Recall Bulletin

PRODUCT SAFETY RECALL

SUBJECT: Shift Lever Indicator May Not Display Correct Gear

MODELS: 2008-2010 Chevrolet Malibu
2008-2010 Pontiac G6
2007-2010 Saturn AURA
Equipped with 4-Speed Automatic Transmission (ME7/MN5)

3256032

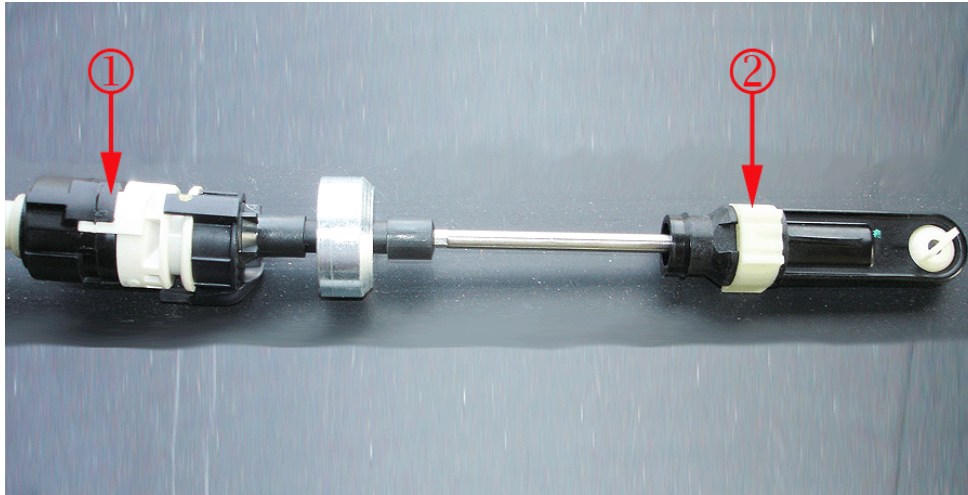
Note: Determine if field action bulletin 09041A has been completed. Inspect the shift cable for the presence of a clam shell cover that surrounds the shift cable locking tabs.

- If the clam shell cover is installed, no further action is required. Refer to the *Warranty Transaction Information* section of this bulletin. Submit a transaction using labor code V2743.
- If the clam shell cover is NOT installed, determine if the transmission shift cable is a first or second design cable.

2269489

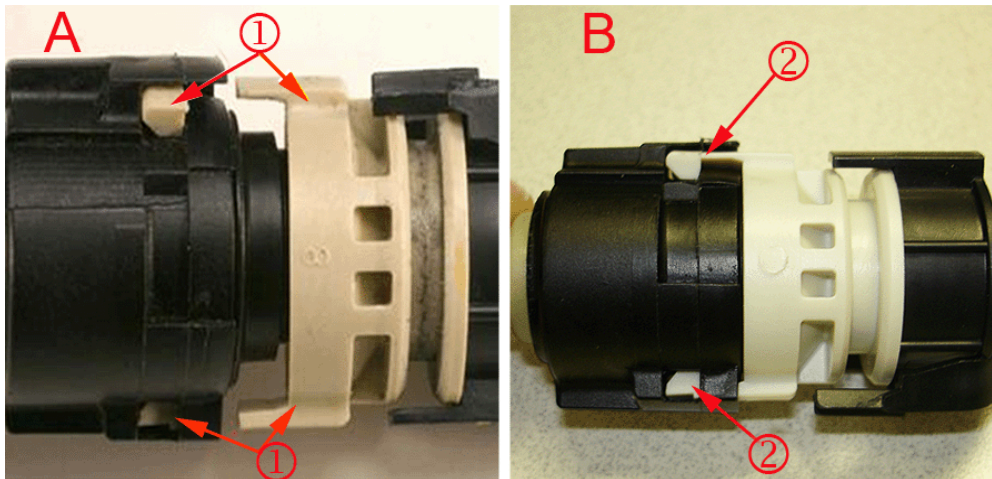
1. Open the hood and locate the transmission shift cable.
2. Determine if the transmission shift cable locking tabs are fractured and separated.

2269486

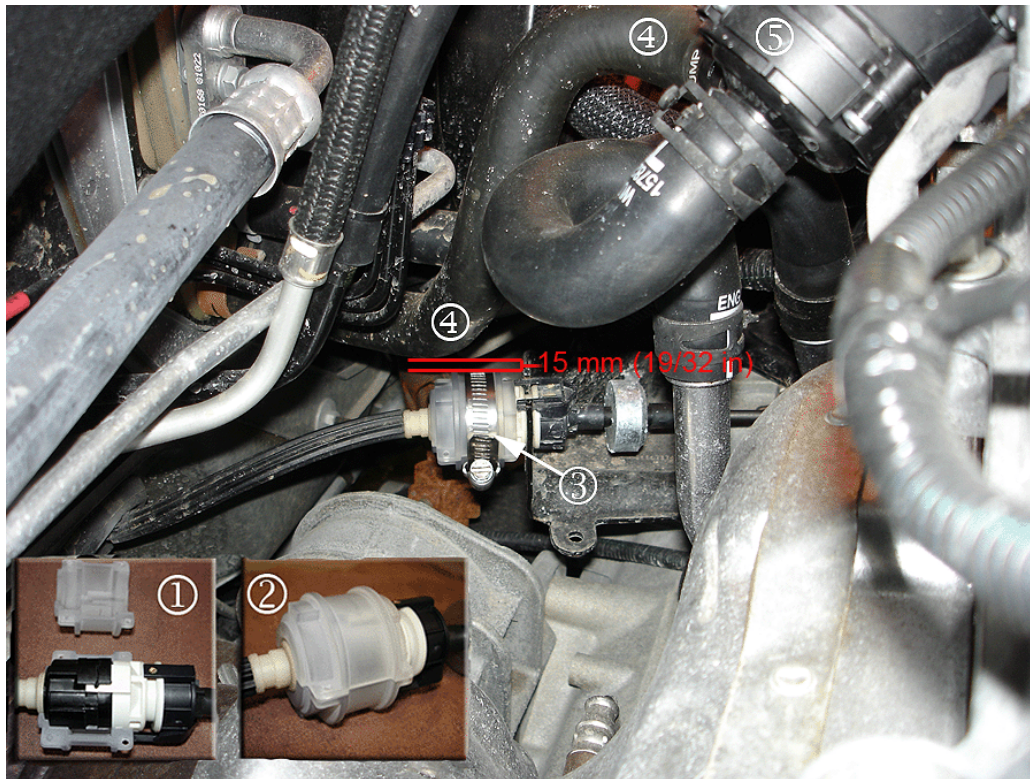
- If the transmission shift cable locking tabs (1) are fractured and separated (A), remove the transmission shift cable and replace it with a new one. Refer to *Floor Shift Control Cable Replacement* or *Range Selector Lever Cable Replacement* in SI. **Also install a transmission shift cable kit with the new shift cable.**
- If the transmission shift-cable locking tabs (2) are NOT fractured and separated (B), install the transmission shift cable kit. Proceed to Step 3.

3. Install the clam shell (1) (2) over the shifter cable locking tabs.
4. Install the service clamp over the clam shell (3). Position the clamp fastener head away from the inlet coolant hose (4). **Tighten the clamp to 4 N·m (35 lb-in).**
5. Ensure that there is 15 mm (19/32 in) of clearance between the inlet coolant hose (4) and the clam shell (3). On hybrid equipped vehicles, it may be necessary to reposition the inlet coolant hose (4) to achieve the required 15 mm (19/32 in) of clearance. **To reposition the inlet coolant hose (4) on hybrid equipped vehicles, locate the heater cooler pump (5) and perform Steps 5.1-5.4.**
